# Access Compliance Report

## Public Rights-of-Way

Intersection ID: 27404	Main Street: BALLANTYNE COMMONS PY	Cross Street: MEADOW RUN LN	Location: SW
ADA ID: 21390999313A	Ramp Type: Perp	Initial Pass/Fail: Fail	Overall Compliance: No
Codes/Mitigation Info/Possible Solution		Field Measurements/Component Compliance	
Severity Score: 21.25

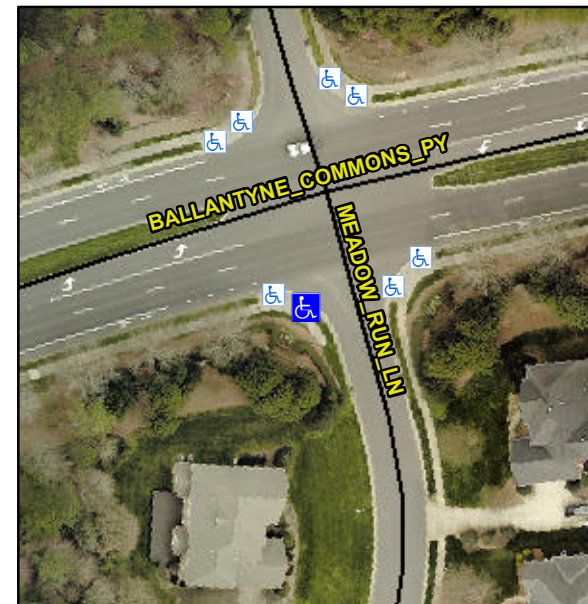
**Not Found, R304.5.1, R304.2.2**

Compliance	Description	Data	Compliance	Description	Data
N/A	Ramp Length (in)	107.0	No	Ramp Slope (%)	8.5
No	Ramp Width (in)	42.0	Yes	Ramp XSlope (%)	1.3
N/A	Flare Type LT	N/A	N/A	Flare Type RT	N/A
N/A	Flare Slope LT (%)	N/A	N/A	Flare Slope RT (%)	N/A
N/A	Flare Traversable LT?	N/A	N/A	Flare Traversable RT?	N/A
N/A	Landing Length (in)	N/A	N/A	DWS Provided?	N/A
N/A	Landing Width (in)	N/A	N/A	DWS Contrast?	N/A
N/A	Landing Slope (%)	N/A	N/A	DWS Length (in)	N/A
N/A	Landing X Slope (%)	N/A	N/A	DWS Full Width?	N/A
N/A	Landing Curb? (Y/N)	N/A	N/A	DWS Offset (in)	N/A
N/A	Shared Landing?	N/A			
N/A	Gutter Ponding?	N/A	N/A	Gutter Slope (%)	N/A
N/A	Gutter Lip Ht (in)	N/A	N/A	Gutter X Slope (%)	N/A
N/A	Painted X Walk1?	No	N/A	Painted X Walk2?	N/A
	X Walk 1 Direction	To E		X Walk 2 Direction	N/A
N/A	X Walk 1 Width (in)	N/A	N/A	X Walk 2 Width (in)	N/A
	X Walk 1 Slope (%)	4.9		X Walk 2 Slope (%)	N/A
	X Walk 1 X Slope (%)	0.8		X Walk 2 X Slope (%)	N/A

**Remove & Replace Entire Ramp.**
